PIP-II Beam Instrumentation (BI) Preliminary Design Review Report

Document number: ED00014582

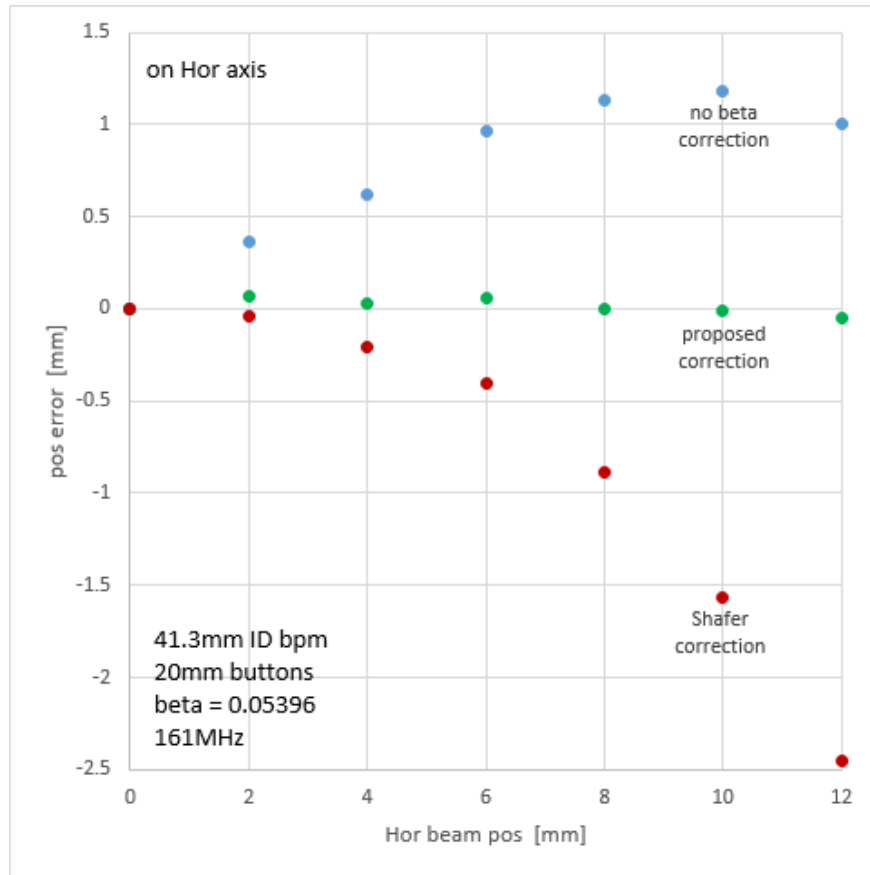
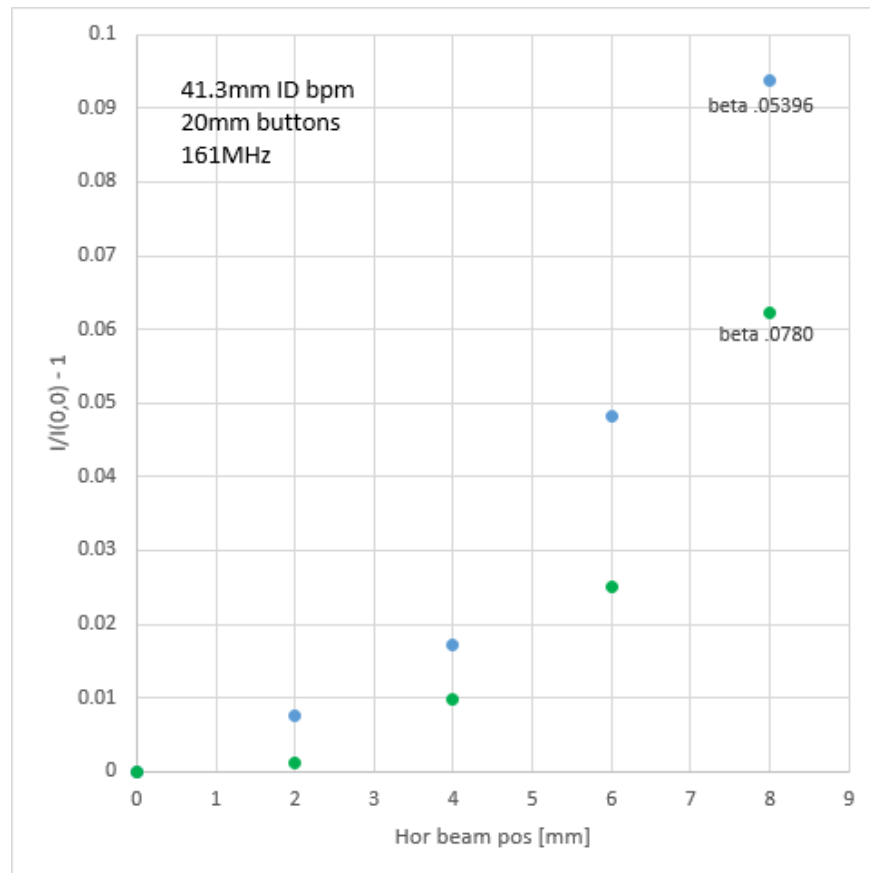
- Accounting for beta over the working aperture of a bpm may require more attention. For example, at $\beta = 0.054$ in a 40mm bpm, the 1% amplitude requirement will be exceeded for beam positions greater than about 3mm. Using the Shafer beta correction for position, the 0.1mm position requirement will also be exceeded. See plots below showing position and intensity error versus beam position obtained from a CST Microwave Studio model:
